Development Review Committee

Re: <u>Trailside Townhomes – Site Plan and Plat Amendment Request</u>

Application No.:	SPR-58-2022 and SUBD-111-2022
Applicant:	John Wheatley, representing IKON Development
Project Location:	2142 East Brookings Dr.
Current Zoning:	RR-22 (Rural Residential), RR-43 (Rural Residential), and RM (Multi-
	family) Zone
Acreage:	19.37 Acres (Approximately 843,757 ft ²)
Request:	Request for approval of a Site Plan and Plat Amendment in the
	RR-22 and RR-43 zones in order to develop the vacant property
	with 152 townhomes.

EXHIBIT G LANDSCAPE AND AMENITY PLAN

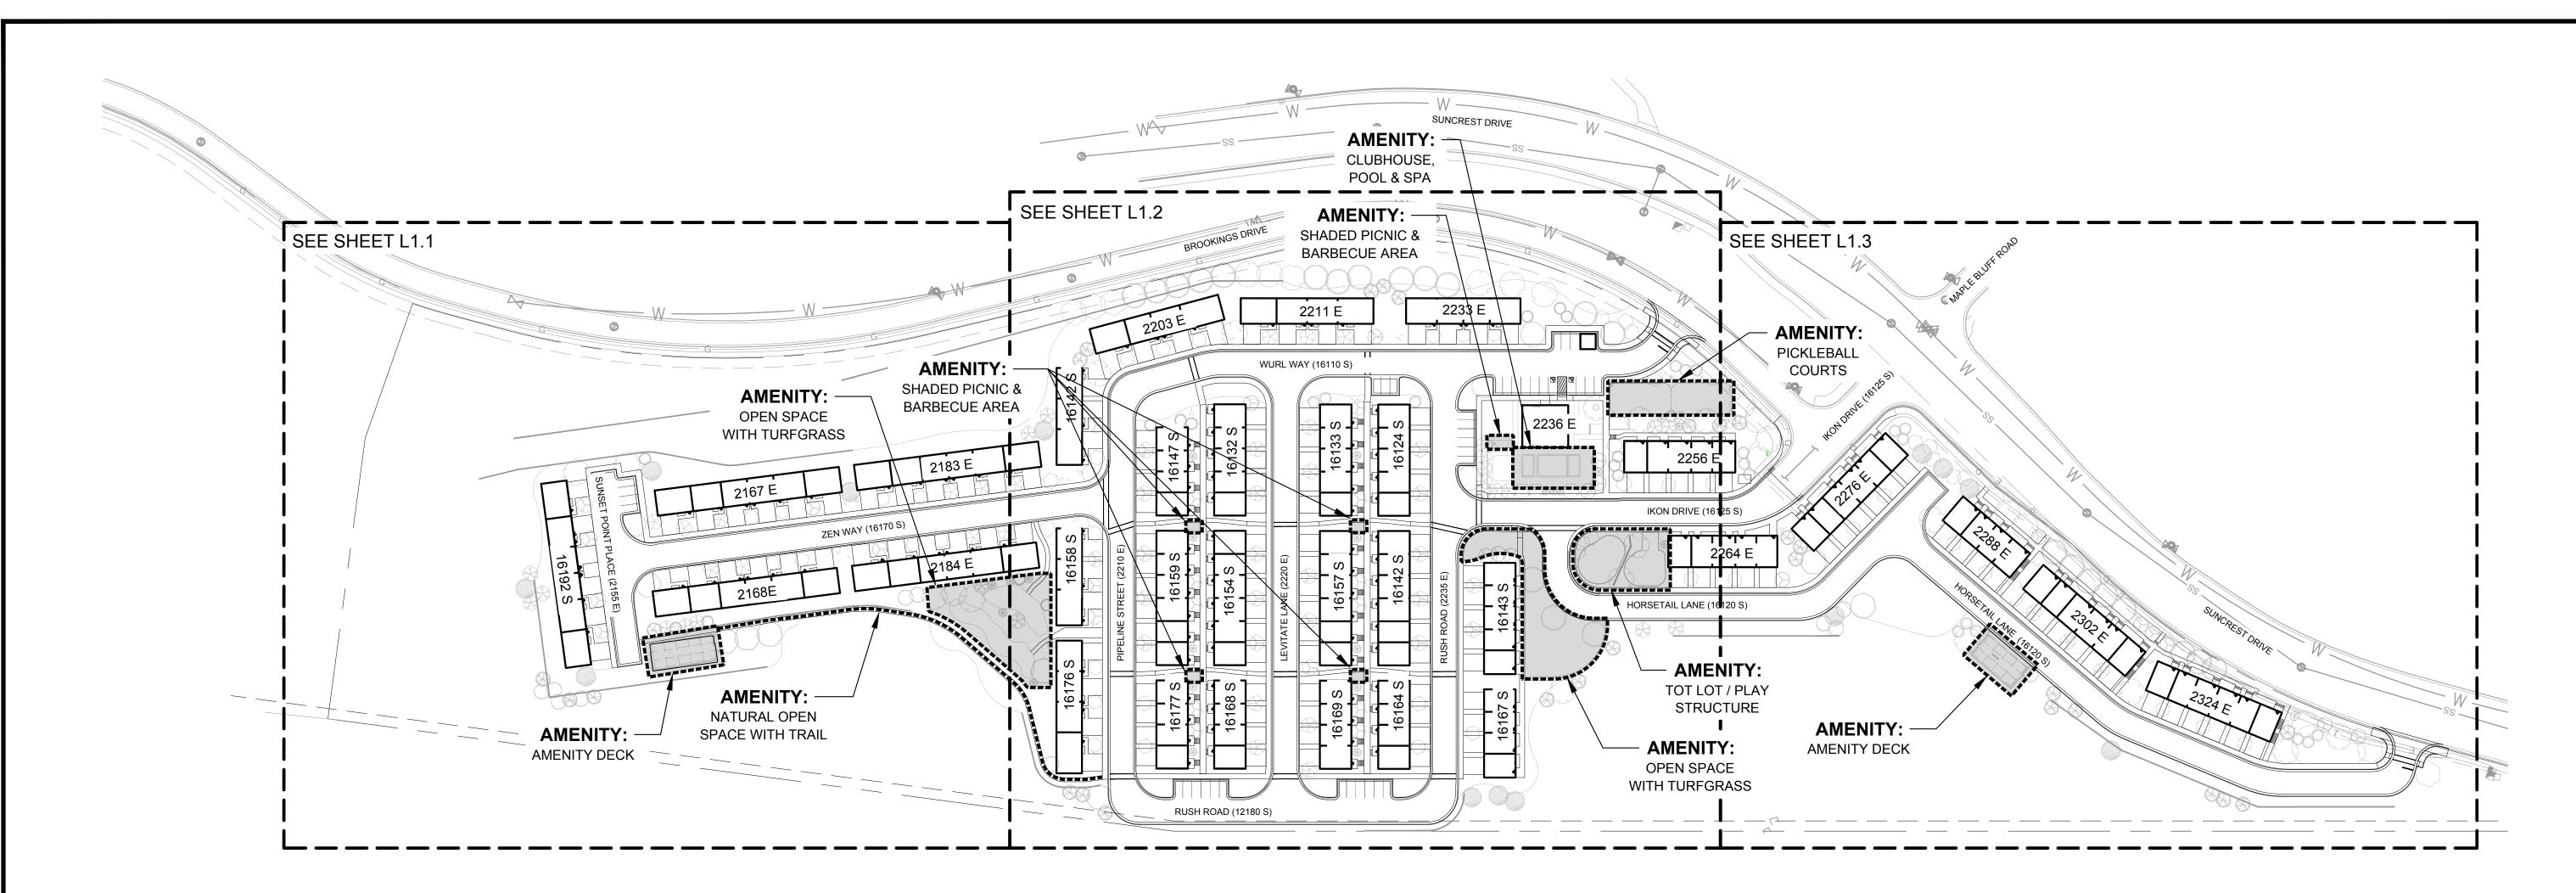
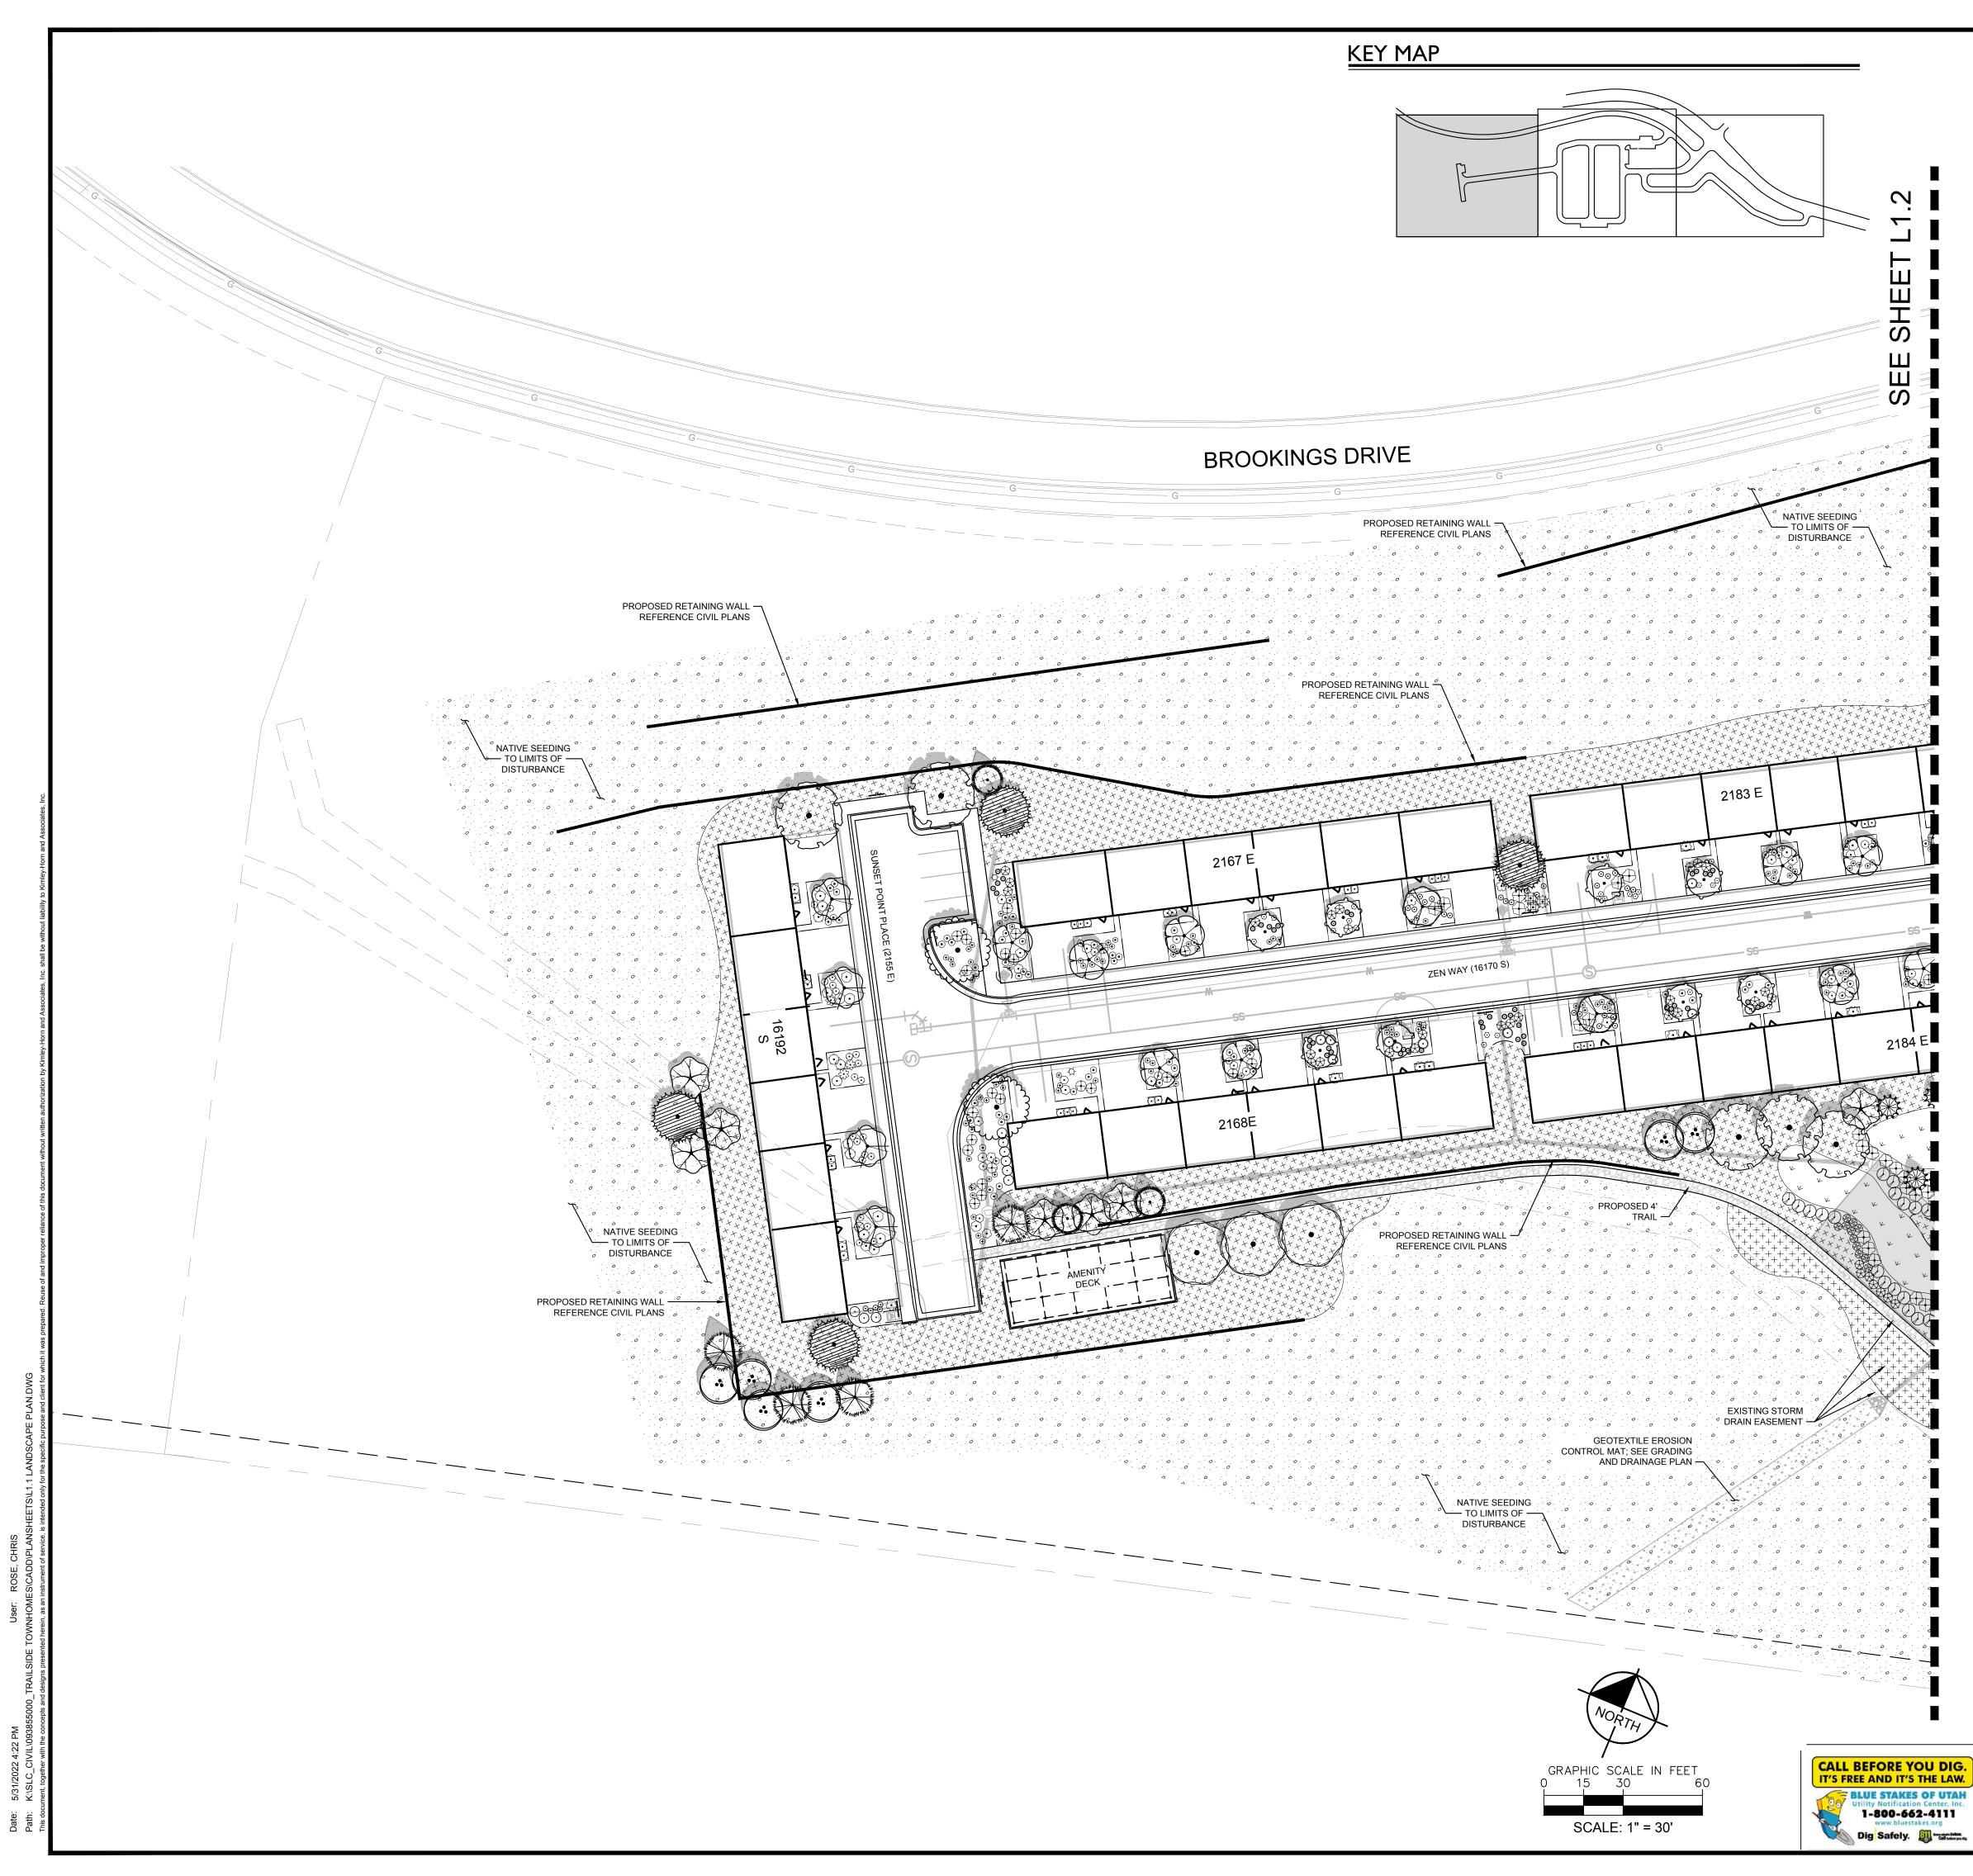
Landscaping and Lot Coverage. The landscape plan includes substantial natural open space, about 2/3rd of the property will be in natural open space (Exhibit G). The other 1/3rd will be made up of amenity space and landscaped areas adjacent to buildings. Amenities provided include a clubhouse, pool, hot tub, tot lot, picnic areas, and view decks.

Table 5	Landscaping Design Requirements			
Standard	DCMC Requirements Proposal Notes			
Lot Coverage	40% Max	29.8%		
Overall Landscaping Coverage	30% Min	34%		
Buffer Landscaping	NA	NA		
Water Wise Landscaping	NA	The majority of the property is in native grasses.		
Street Trees	From approved tree list	Not all listed trees are from approved list	Changes required	
Amenities	5 required	7 provided

- A. Update the tree plat list so that all trees located on a street are from the approved Draper Street Tree list.
- 3. Prior to Land Disturbance Permit issuance, amend civil plans to address all outstanding comments:
